APPLICABLE TO:
 PUBLICATION NO. NEDO-30825
 T. I. E. NO. 84NED042
 TITLE Core Spray Sparger Crack
Analysis for Edwin I. Hatch
Nuclear Power Station, Unit 1
 ISSUE DATE November 1984

ERRATA And ADDENDA SHEET

NO. 1
 DATE December 1984
 NOTE: *Correct all copies of the applicable publication as specified below.*

Table 4-1

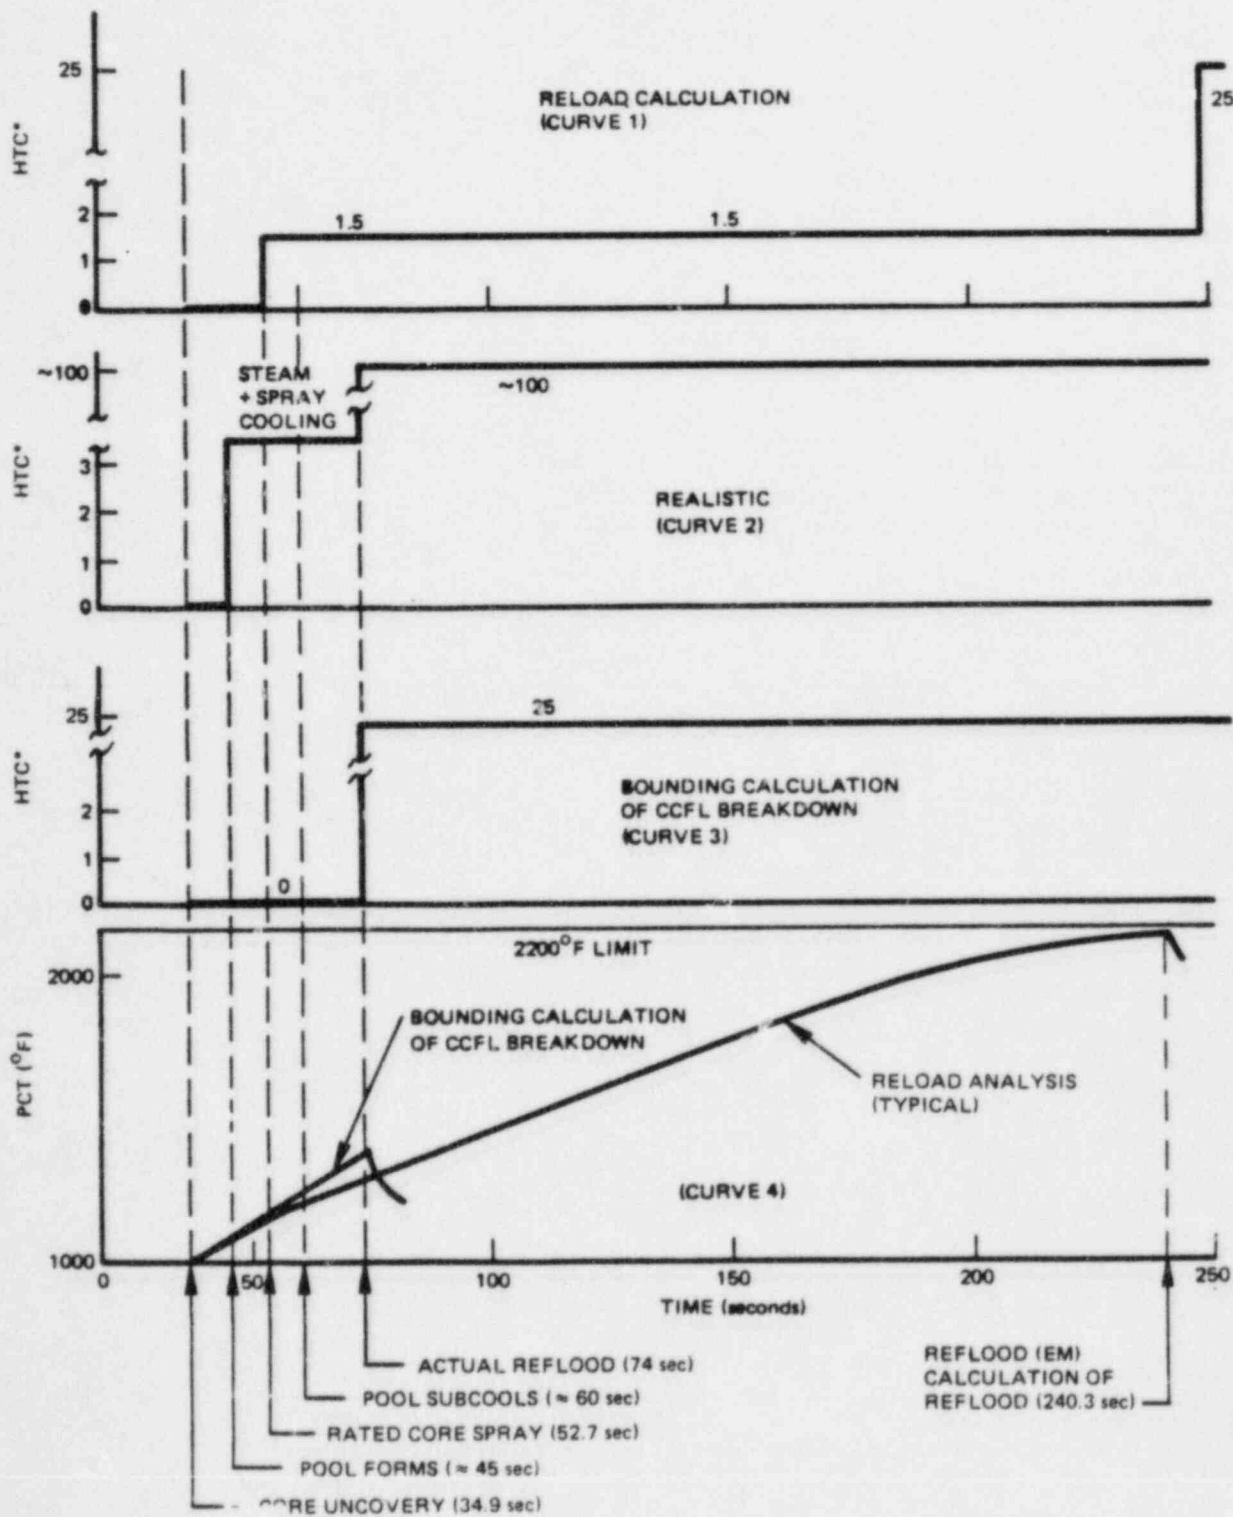
ITEM	REFERENCES (SECTION, PAGE PARAGRAPH, LINE)	INSTRUCTIONS (CORRECTIONS AND ADDITIONS)
1	Page 4-8	Replace page 4-8 with new page 4-8 (Change bar in right-hand margin indicates area where report has been revised.)
